**Marion County
Board of County Commissioners**

**PLANNING & ZONING SECTION
STAFF REPORT**

Public Hearings	P&Z: 1/26/2026	BCC: 2/17/2026
Case Number	260207ZP	
Application Number	PL PUD-000131-2025	
Type of Case: Rezoning for PUD Modification	FROM: Planned Unit Development (PUD) – RV Park with private amenities TO: Planned Unit Development (PUD) – RV Park with public amenities with limited increased height allowance to 145’ for waterslide amenity (only).	
Owner	8M Holdings, LLC.	
Applicant	Fred N. Roberts, Jr., Esq. Klein & Klein, PLLC.	
Street Address / Site Location	18365 NW 45 th Avenue Road	
Parcel ID Number(s)	02781-000-00	
Property Size	140.91 acres	
Future Land Use	Commercial	
Zoning Classification	Planned Unit Development (PUD)	
Overlay Zones / Special Areas	Outside the Urban Growth Boundary (UGB), In Farmland Protection Area (FPA); Orange Lake Environmentally Sensitive Overlay Zone (ESOZ), County-wide Secondary Springs Protection Overlay Zone (S-SPOZ), Marion County Utilities NW Regional Service Area

Figure 7 – Prior PUD Concept Plan Excerpt with Proposed Revisions

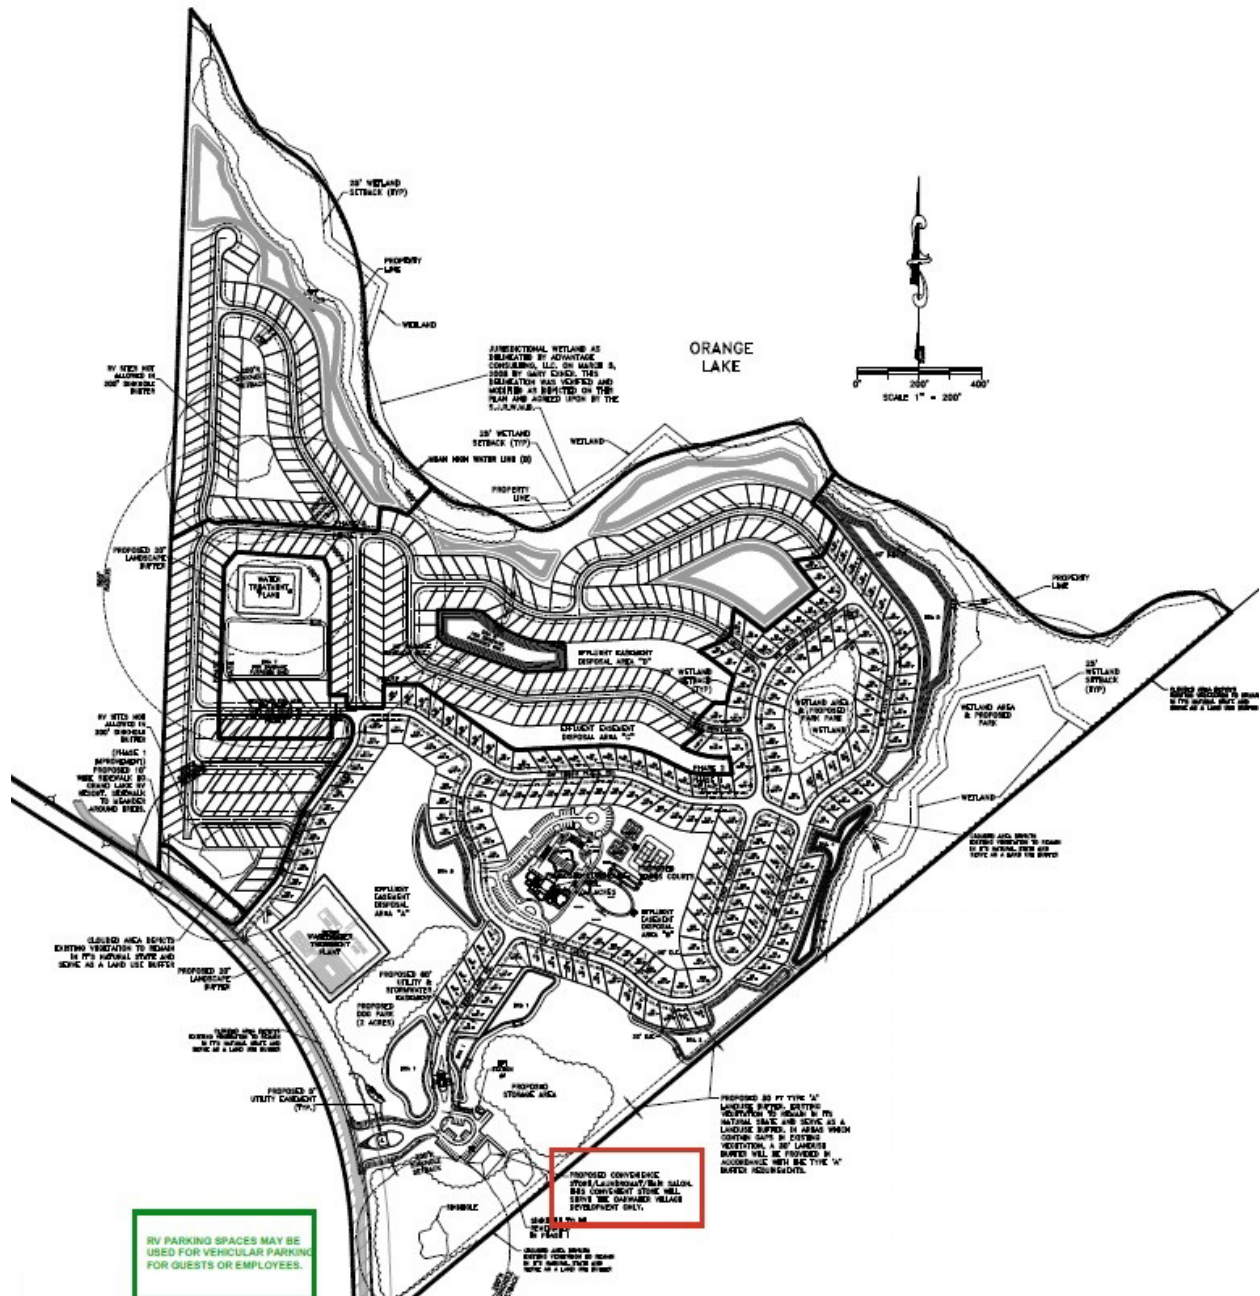
- 1) Delete: *"PROPOSED CONVENIENCE/STORE/LAUNDROMAT/HAIR SALON. THIS CONVENIENT STORE WILL SERVE THE OAKWATER VILLAGE DEVELOPMENT ONLY"* and
- 2) Add: *"RV PARKING SPACES MAY BE USED FOR VEHICULAR PARKING FOR GUESTS OR EMPLOYEES. "*

The proposed text changes are reference in Figure 7 below with the red identifying the deleted language and the green indicating the added language. Further the PUD Conceptual Plan reflecting these changes is provided as Attachment B, followed by the project's ongoing approved Major Site Plans as Attachments C and D.

A final adjustment is requesting enabling a PUD height increase for the recreational slide system components west of the pool area, planned area, increasing the height allowance from 40-feet to 145-feet while maintaining the remainder of the PUD's height limit at 40-feet for all other structures (e.g., clubhouse, maintenance building, park models, etc.). The
